DESIGN UPGRADE
 Change Effective:
 Immediately

Rexnord 5930 Series MatTop Chain Design Upgrade

Plug Design

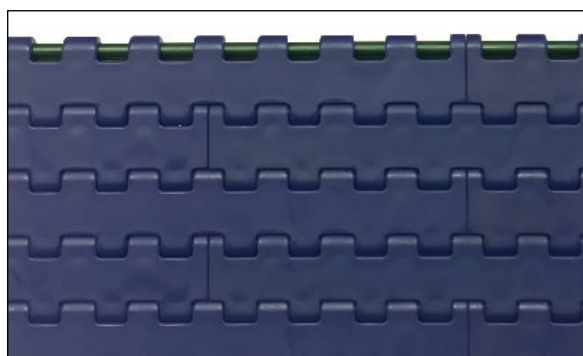
Upgraded Plug

The upgraded design uses the Rexnord 1500 Series MatTop Chain plug in the distinctive yellow color for easy identification. This plug can be easily assembled by hand and removed with a small screwdriver.

Original Design with One Side Plugs and One Side Blind

Upgraded Design with 1500 Plugs on Both Sides of the Belt

Molded Cutting Lines

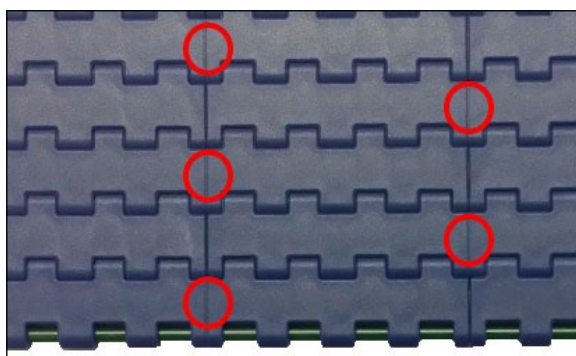
One Module System

The upgraded design is a one-module system which is used as center and end module and can be recognized by its cutting line on the top of the module. This ensures smooth camfer on the side. The main advantage is easy installation and maintenance and reduction of inventory.

Original Design with Multiple Modules

Upgraded Design with Preformed Cutting Lines in One Module

Sprocket Position

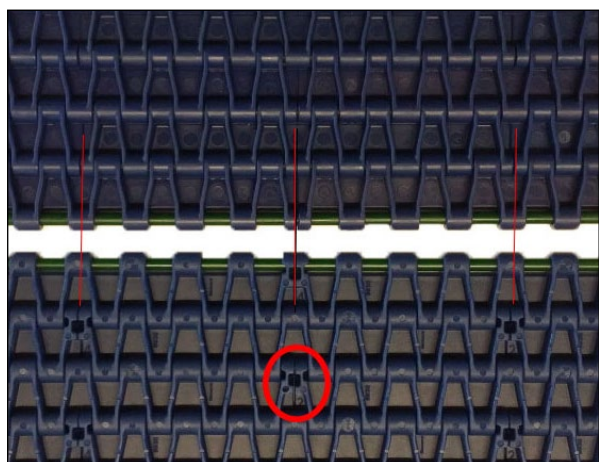
In the upgraded design it is not possible to position the sprocket at a transfer of two modules. The sprocket will need to be positioned in the area between the module transfer.

Red Encircled is the Position on the End of the Module with the Rod Retentions that Makes it Impossible to Place a Sprocket on this Position
